<b>QUALITY ALERT HR.0001</b>
------------------------------

**Title:** Electronics Cover - 28990

**Part Number:** 28990

Installation Instructions

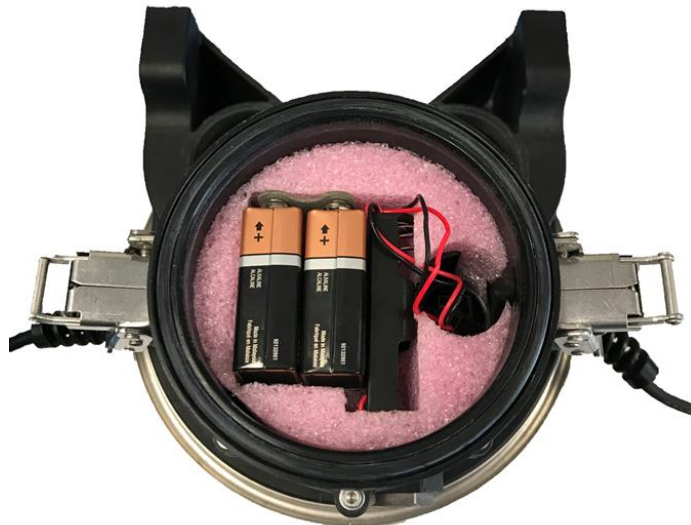
**Product Issue:** Aluminum has proven to be a suboptimal material choice in this application and can be affected by corrosion, resulting in a leak of the OPV seal. We have upgraded the material to 316 stainless steel and are now making this part available as a replacement for all units sold by AUP, as well as new production from Hollis Rebreathers.

**Remedy:** For every Prism 2 manufactured between January 2012 and June 2017, we recommend an immediate inspection by the user and, if corrosion is noticed, replacement of part 28990 – Electronics Cover with part 28990S.A – Electronics Cover Assembly, SS. This new cover assembly also includes a new over pressure relief valve pre-installed.

**1. Remove Old Battery Cover**

- a. Unhook both latches and remove old aluminum battery cover

**3. Install New Stainless Battery Cover - 28990S.A**

- a. Secure both latches and ensure battery cover is seated properly
- b. Your Prism 2 electronics cover is now upgraded
- c. If you have any additional questions or concerns, please contact [service@hollisrebreathers.com](mailto:service@hollisrebreathers.com) or call 385.770.7430
